# D785N

## CMS CSC DDU VERSION 4

## MODIFICATIONS TO D785A PCB

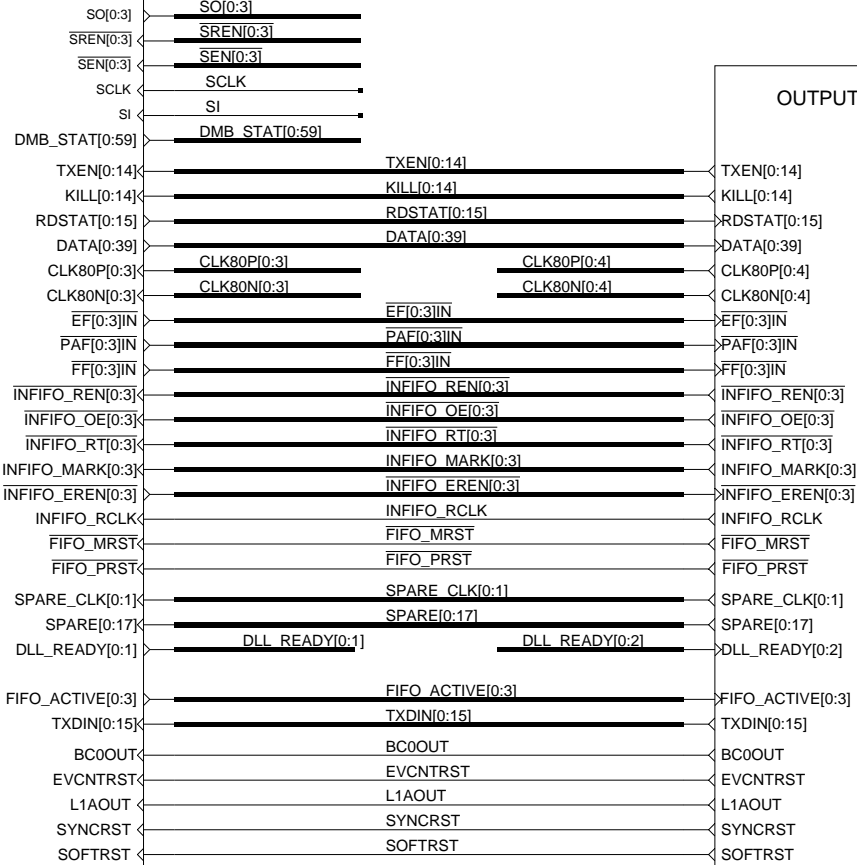
JTAG0 (Emergency VME) ---> CPLD (driven by cable or FPGA1)  
JTAG1 (DDU Control) ---> EPROM1 ---> FPGA1 (driven by cable, CPLD or FPGA1): for now TDO1 goes only to cable, but future version should feed TDO1 back into FPGA1  
JTAG2 (GBE Control) ---> EPROM2 (driven by cable or FPGA1)  
JTAG3 (GBE Control) ---> FPGA2 (driven by FPGA1)

1. PULLUP'S ADDED TO SELECT JTAG TDO PINS. THE FPGA TDO PINS ARE OPEN DRAIN OUTPUTS. (330Z to 2.5V)  
TDO2  
TDO3  
TDO6
2. THE ORIGINAL SERIES JTAG PATH OF THE CONTROLLER PROM1>PROM2>FPGA WAS SPLIT INTO TWO PATHS  
U21 PIN #31 PROM TDO PIN WAS LIFTED FROM PAD.  
U21 PIN #31 PIN GOES TO VME FPGA PIN #AA15 (PROM TDO PIN)  
U21 PIN #31 PAD GOES TO VME FPGA PIN #AB15 (FPGA TDI PIN)
3. RESISTOR DIVIDER ON JTAG HEADER. TO PROTECT 2.5V TOLERANT I/O FROM THE 5V MOJBLASTER.  
R125, R126, R128 CHANGED TO 100Z  
R122, R127, R129 CHANGED TO 330Z  
REMOVE R16 (PULLDOWN ON TCK1). THIS WAS REDUNANT WITH THE RESISTOR DIVIDER.
4. R/C filter added to the DS1033z for hardrst.  
(after programming, the current would increase causing the voltage level to fall

this drop in voltage would cause the reset debouncer to retrigger.  
The power pin was lifted and a 220Z and 47uF capactor were installed to minimize the voltage drop effect.
5. The SD pin from input optical transceiver is a 3.3V signal feeding to 2.5V I/O banks.  
Causes current surges

330Z pulldowns were used to help draw some of the current and  
also keep the FOK signal from floating with no fiber unit installed
6. Switch the 2.5V regulator to a TI unit due to large dropout and maximum current to be exceeded.  
this drop in voltage would cause the reset debouncer to retrigger.  
The power pin was lifted and a 220Z and 47uF capactor were installed to minimize the voltage drop effect.

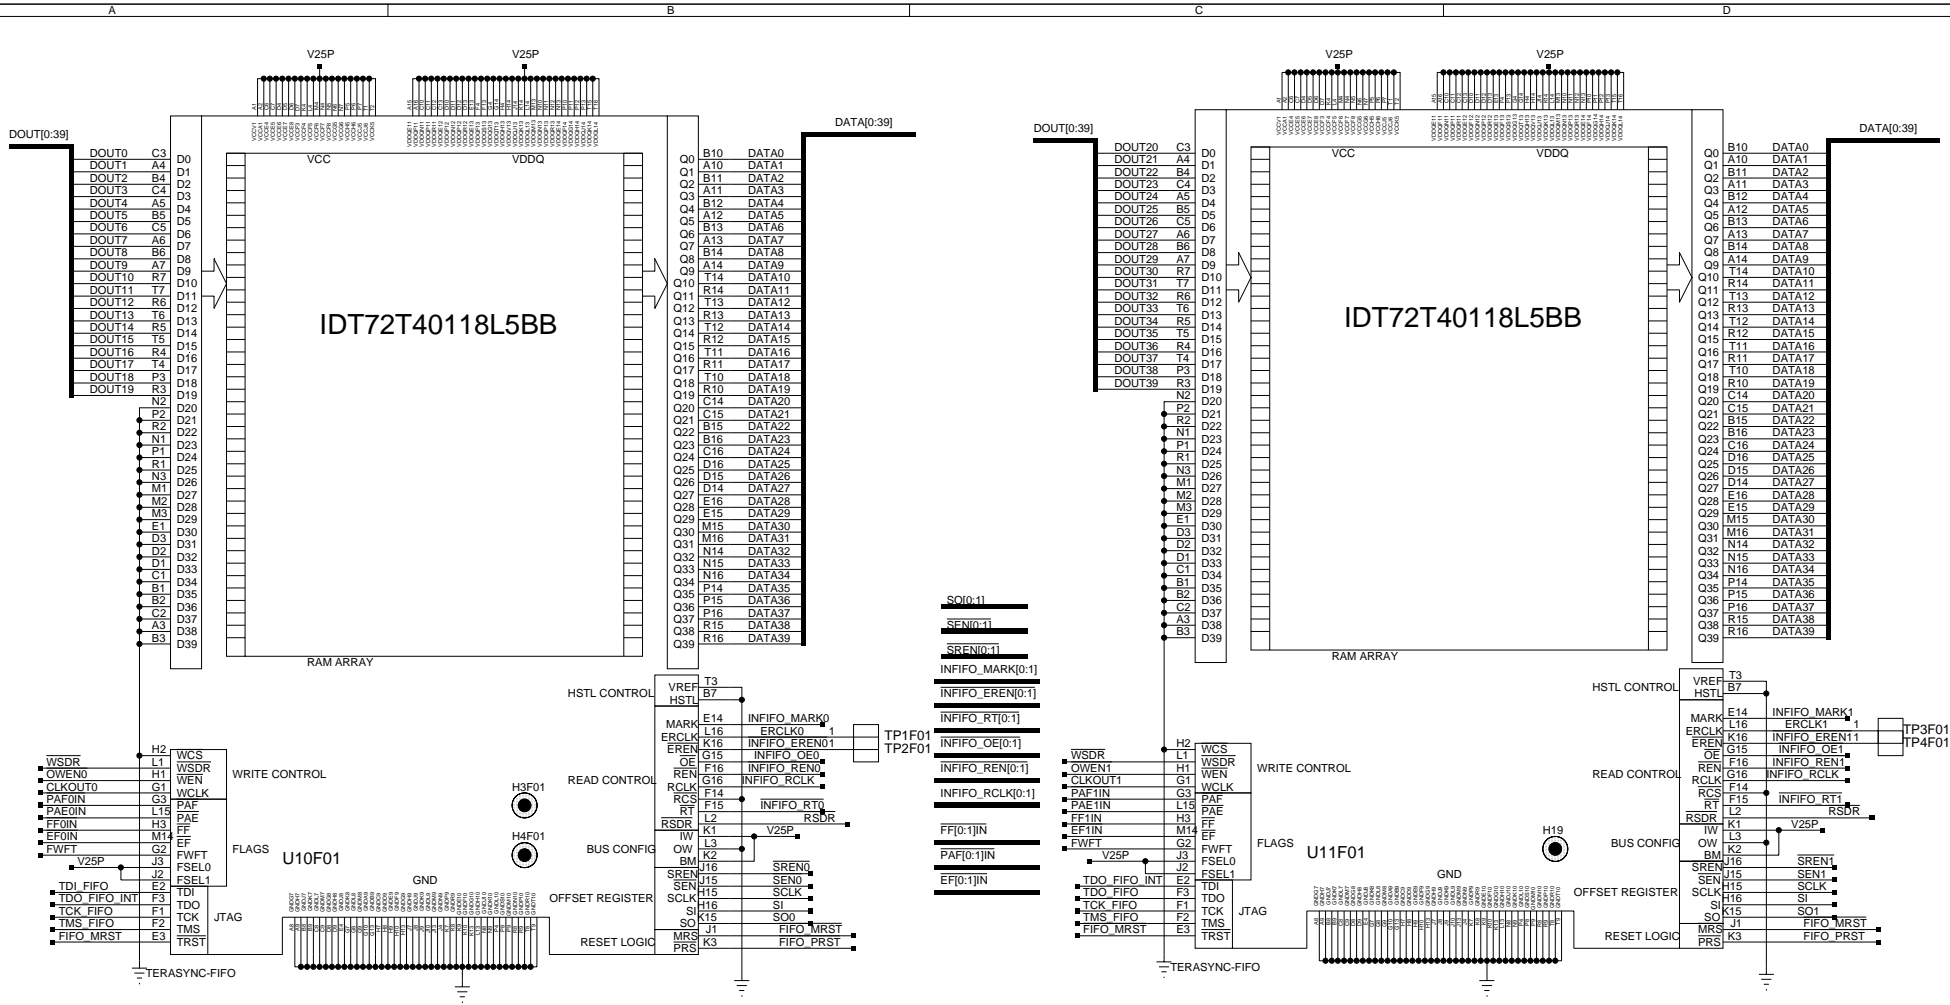
RCS and WCS?????

For now TDO1 goes only to cable, but future version should feed TDO1 back into FPGA1

Test input BNCs are not needed in next version; use those 4 I/O (TBX0, TBXRST, TL1ACC, TL1ARST) for test points instead.

Add "DDU Control" box

# Implement basic S-LINK architecture on DDU board?

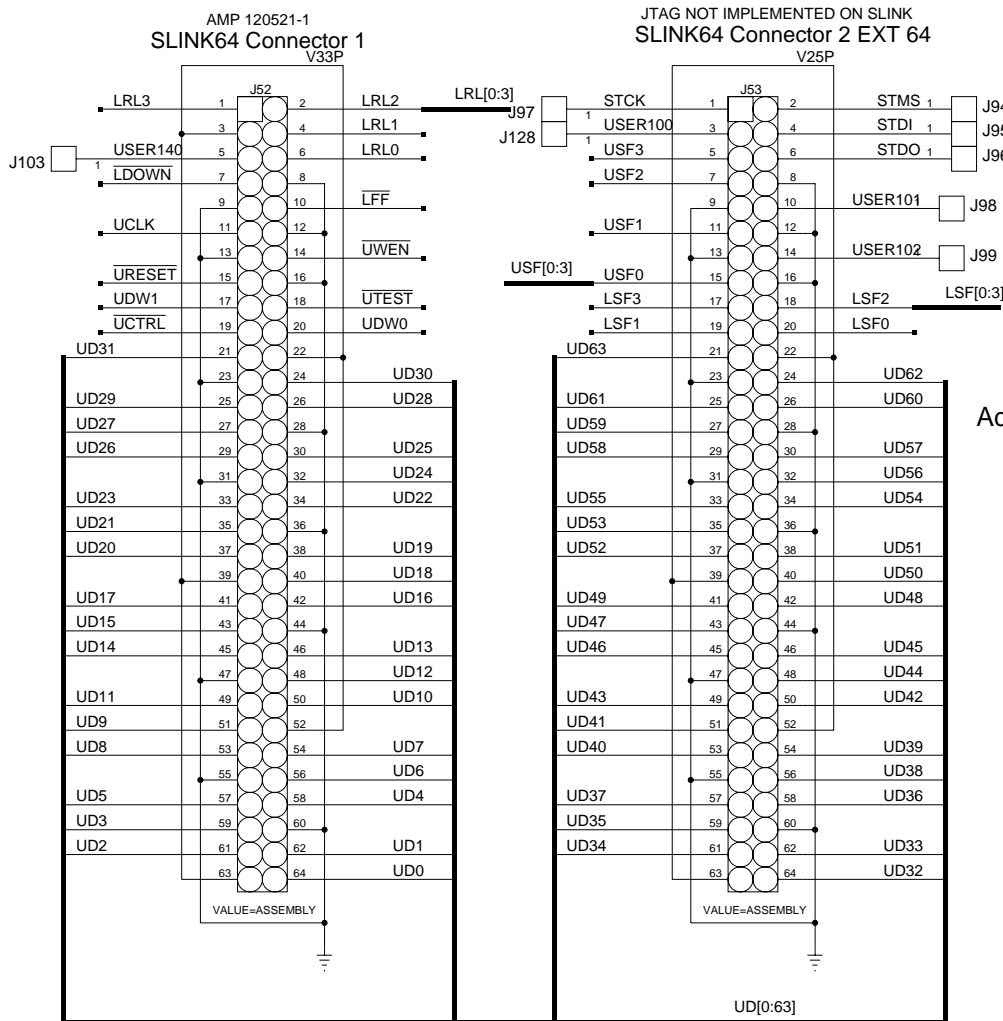
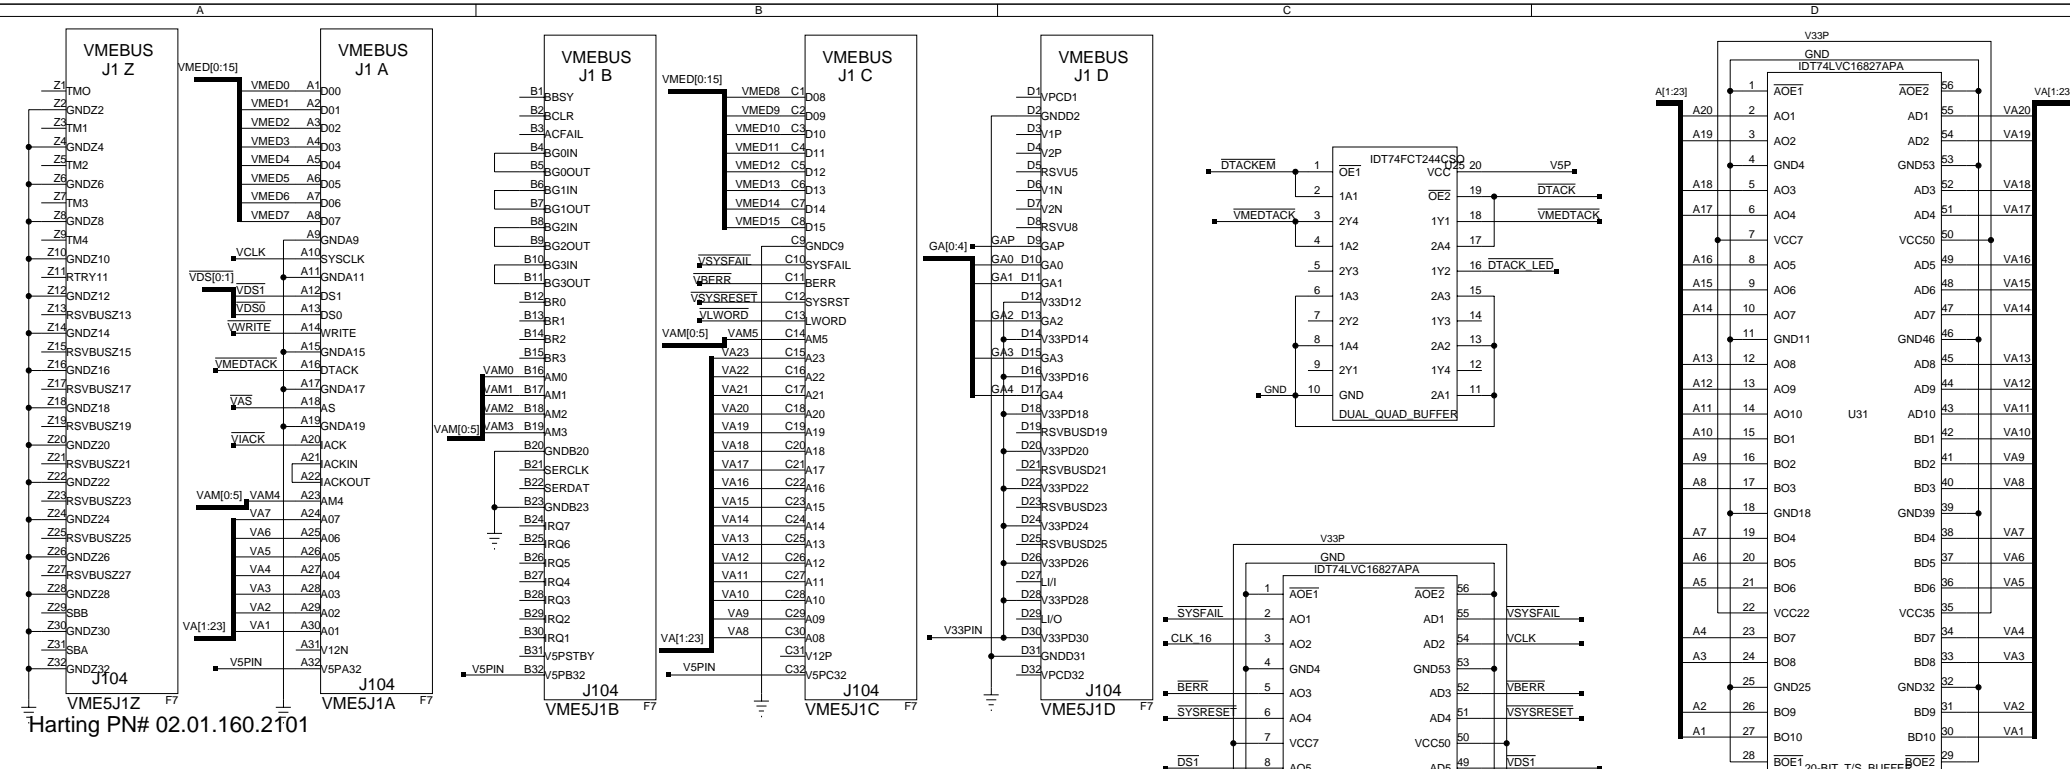
USER140, USER101, USER102 NOT USED  
USER100 IS FOR DESKEW OPTION, NEED TO DRIVE

Add accessible testpoints for UCLK, UWEN, UCTRL very near S-LINK port

fix 3.3v 2.5v on slink
